Subject: Docket 50-482: 10 CFR 50.55a Request I3R-10 for the Third Inservice Inspection Program Interval

**Wolf Creek Nuclear Operating Corporation**  
**10 CFR 50.55a Request I3R-10**  
**Request for Relief from the Pressure Test**  
**Requirements of ASME Section XI IWB-5220**

### Request for Relief from the Pressure Test Requirements of ASME Section XI IWB-5220

M-12BB01

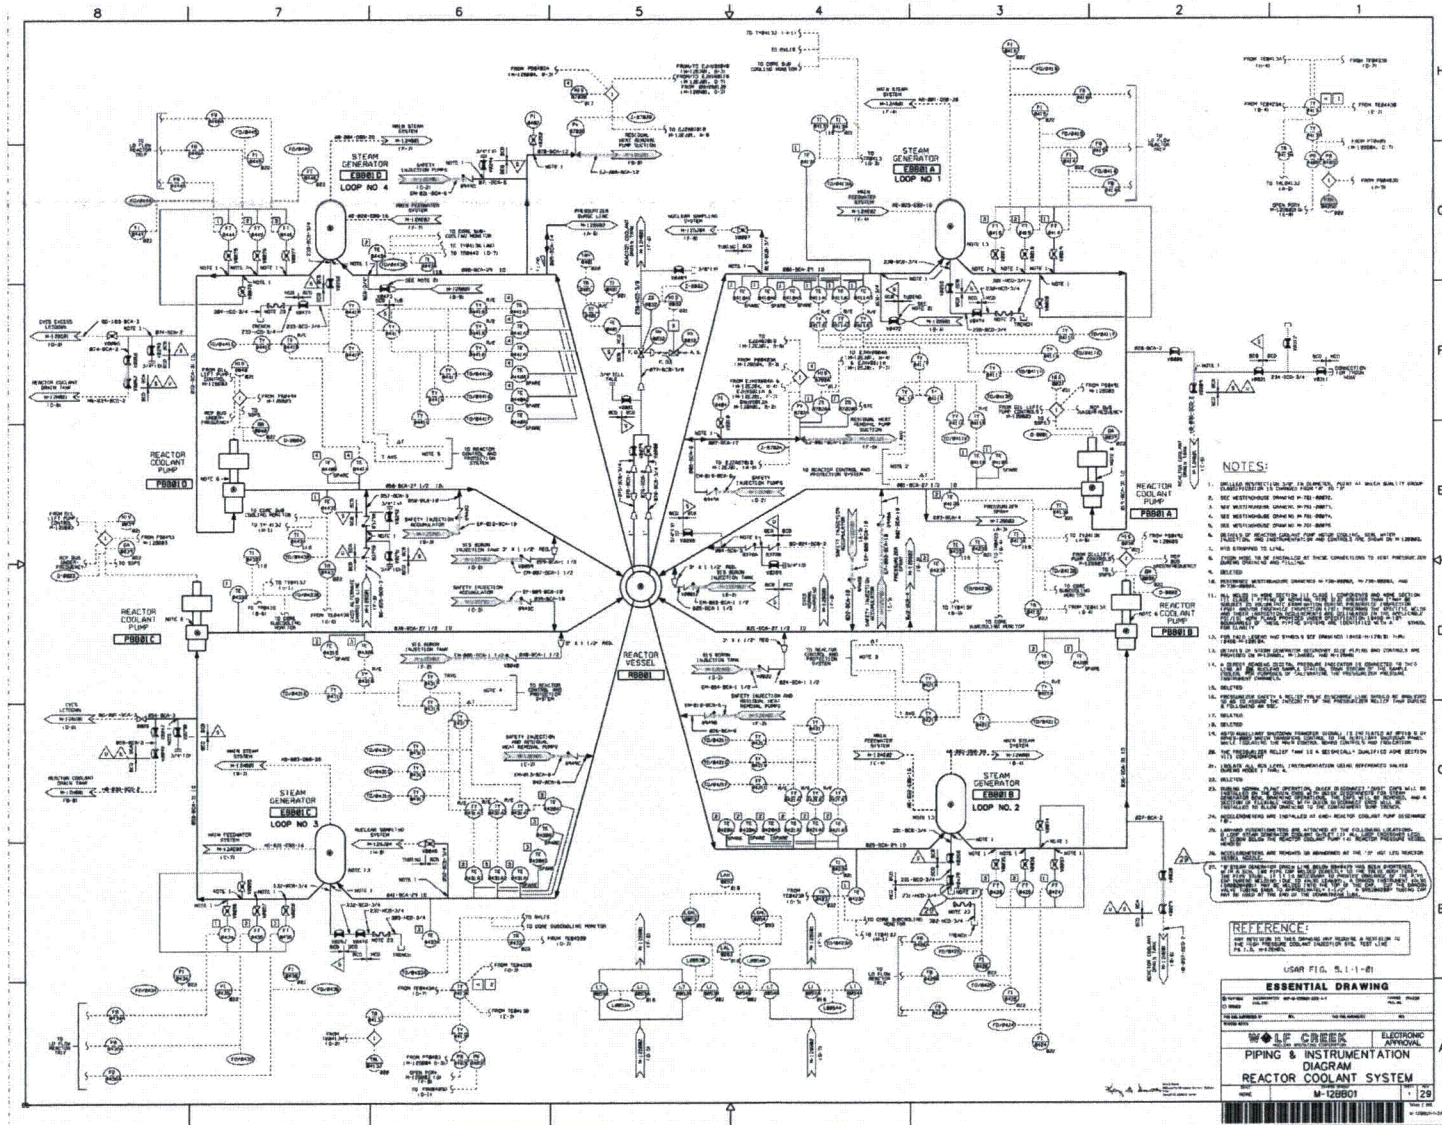
Portion 2 piping is shown on Attachment 2 drawings M-12BB01 and M-12EJ01 while the piping materials and segment lengths, listed by NPS are listed in Attachment 1.

Portion 3 piping is shown on Attachment 2 drawings M-12BB01 and M-12EM02 while the piping materials and segment lengths, listed by NPS are listed in Attachment 1.

Portion 4 piping is shown on Attachment 2 drawings M-12BB01 and M-12EP01 while the piping materials and segment lengths, listed by NPS are listed in Attachment 1.

Portion 5 piping is shown on Attachment 2 drawings M-12BB01 and M-12EM01 while the piping materials and segment lengths, listed by NPS are listed in Attachment 1.

The 2 inch drain piping configuration is shown on Attachment 2 drawings M-12BB01 while the piping materials and segment lengths, listed by NPS are listed in Attachment 1.

M-12BG01

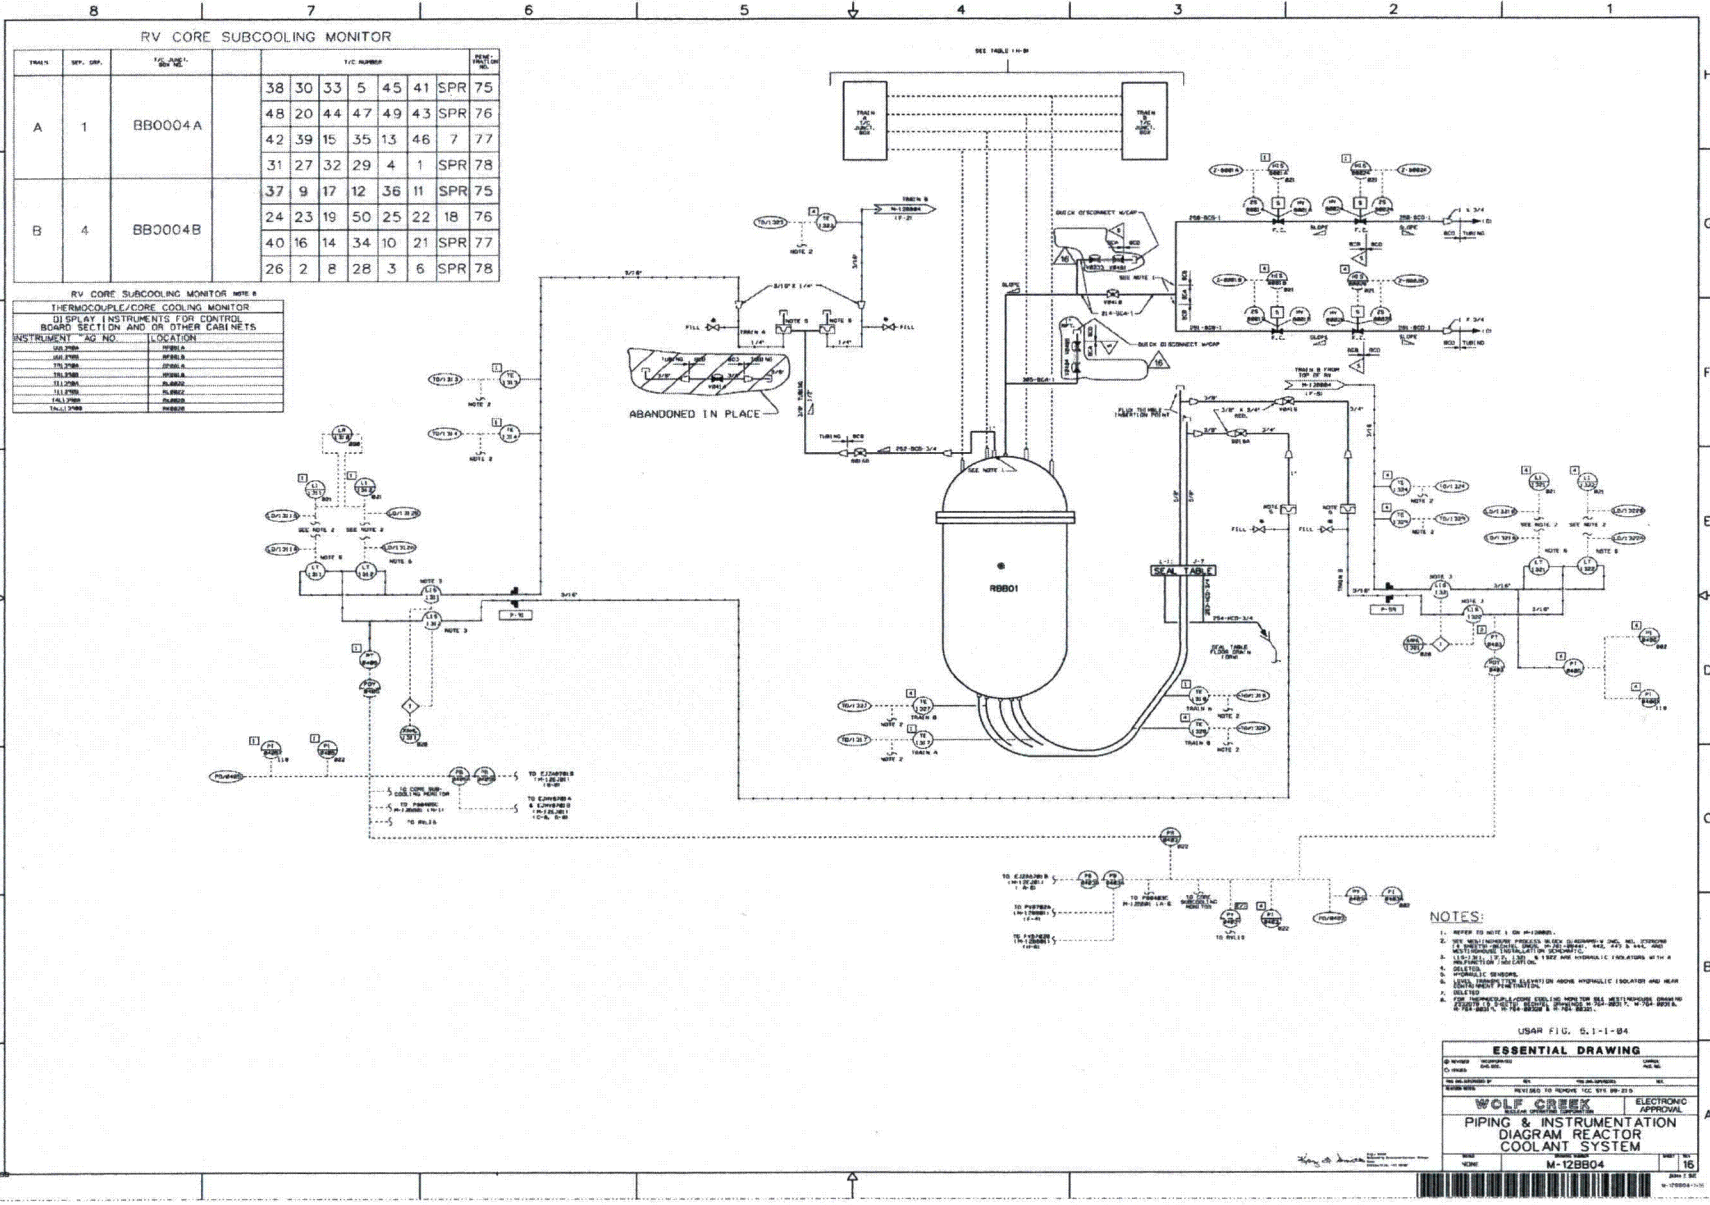
Portion 1 piping is shown on Attachment 2 drawings M-12BB02 and M-12BG01, while the piping materials and segment lengths, listed by nominal pipe size (NPS) are listed in Attachment 1.
